Public Comment on City of Stevenson Draft General Sewer Plan and Proposed Rates

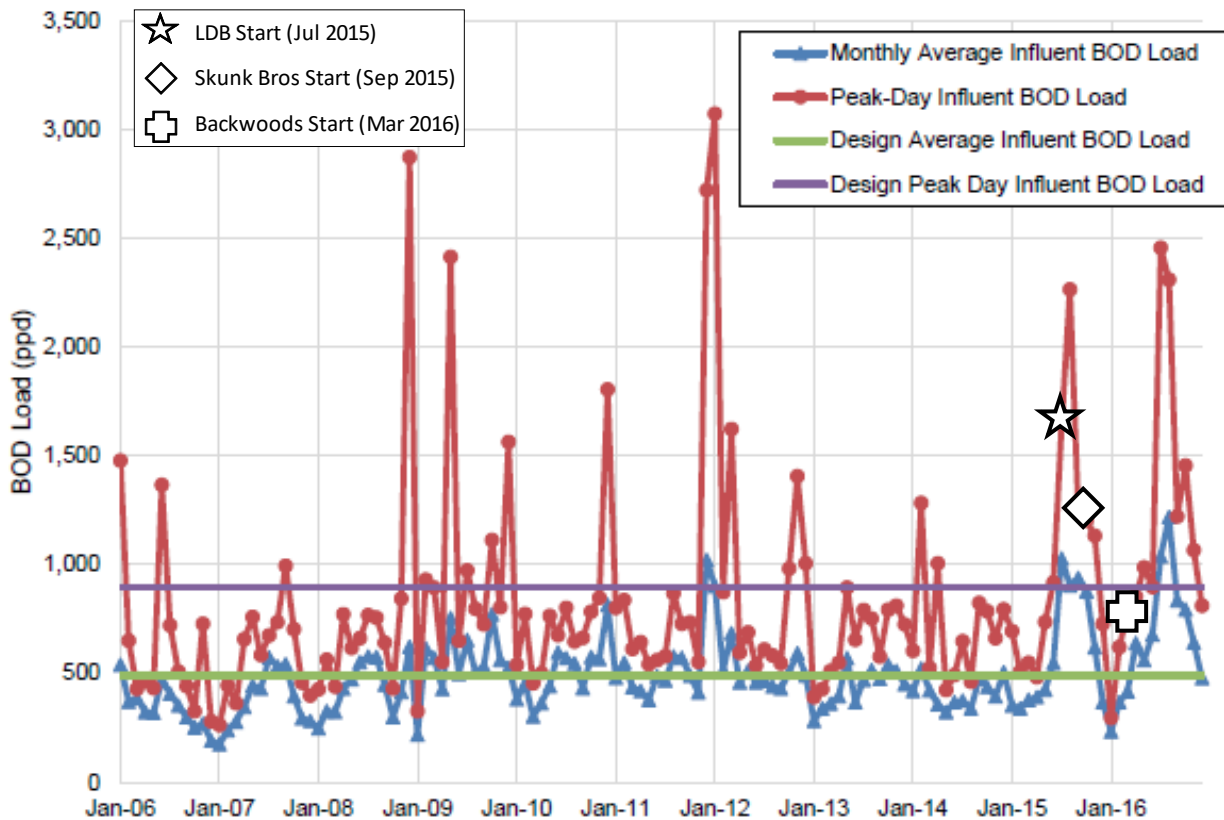
1. As the historical BOD load chart from page 2-9 of the City's draft sewer plan shows, influent BOD loads have been an issue for the City long before LDB, Backwoods and Skunk Brothers began production in Stevenson.
